RBG-47072

SUBJECT: License Amendment Request 2010-04
Heavy Load Movement Over Fuel Assemblies
River Bend Station – Unit 1
Docket No. 50-458
License No. NPF-47

Evaluation of Proposed Changes

Mark-up of Affected Pages

Excerpt of RBS drawing ES-62E-6

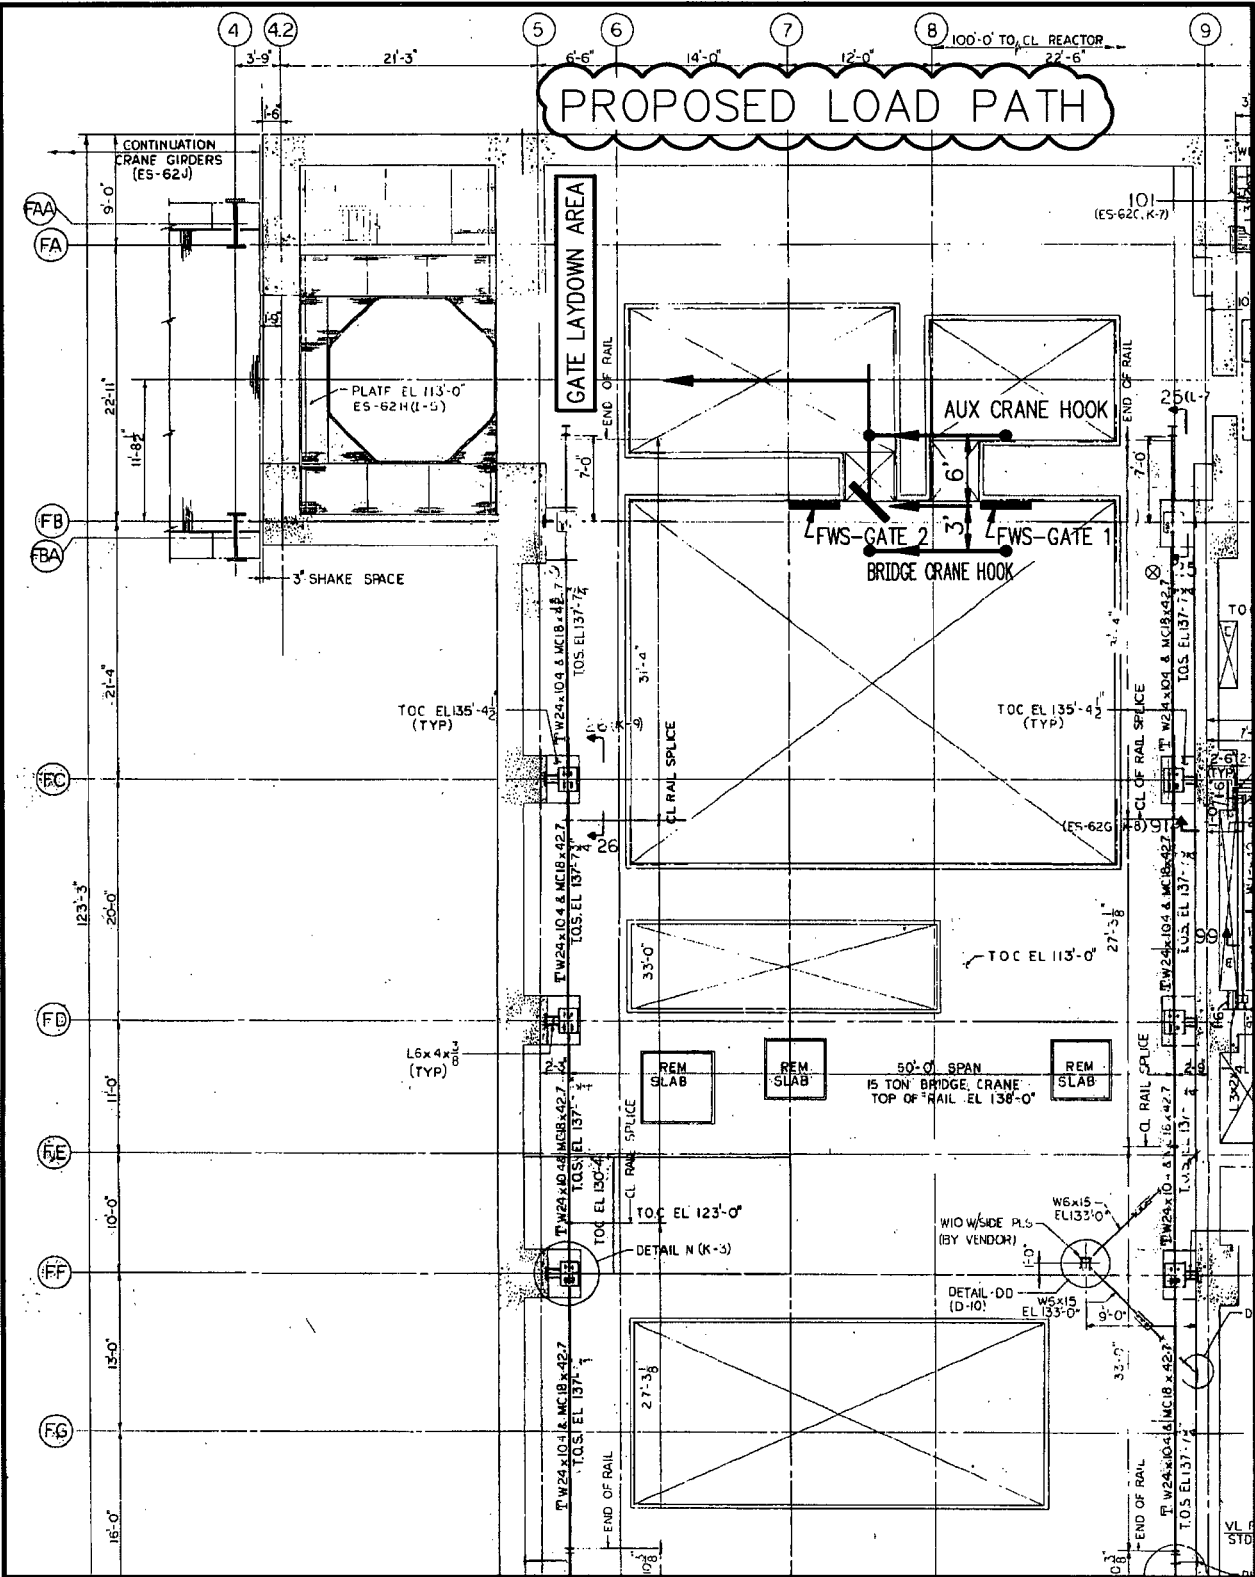
- a. Spent fuel pool gates weigh approximately 1600 lbs. each. Each of these gates are to be lifted using MHF-CRN1, fuel building bridge crane (lifting capacity, 15 tons), and the auxiliary hook of MHF-CRN2, spent fuel cask crane (lifting capacity, 15 tons). Neither of these two cranes can be brought directly over the spent fuel gates. Based on a dry run of the cranes, the closest the bridge crane hook can be brought over the spent fuel gates is approximately 3'-2", and the closest the auxiliary hook of the spent fuel cask crane can be brought over the spent fuel gate is approximately 6'-0". Therefore, the horizontal distance between the two hooks will be approximately 9'-2".

- h. Move the gate northwards parallel to the east wall of the spent fuel pool by moving both the cranes simultaneously until the gate reaches the opening for FNS-GATE2.

- i. Rotate the gate enough to be able to move it through the gate opening in the wall. Move the gate under the auxiliary hook of the cask crane by using the two upper hoists and ensuring that the bottom of the gate clears the bottom of the opening in the wall. At this position, the full load of the gate will be carried by the auxiliary hook of the cask crane.

- j. Move the gate eastward to the center of the cask crane.

- k. Raise the pool gate by raising the cask crane hook until the bottom of the gate is approximately 6" above the upper shelf in the cask pool).
- l. Move the gate northward and place it on the floor close to the north wall with the upper part of the gate resting against the north wall. As a good practice, tie resting gate to pool handrails.
- m. Reduce the length of the rigging above the gate by removing the hoists and dynamometer. Reattach the auxiliary hook.
- n. Raise the gate to clear the floor or any obstructions by approximately 6" and move it to its laydown area.
- o. Follow the above sequence in reverse order for reinstallation of the gate.
- p. Perform rigging for FNS-GATE2, when required, in a manner similar to that outlined for FNS-GATE1.

PROPOSED LOAD PATH
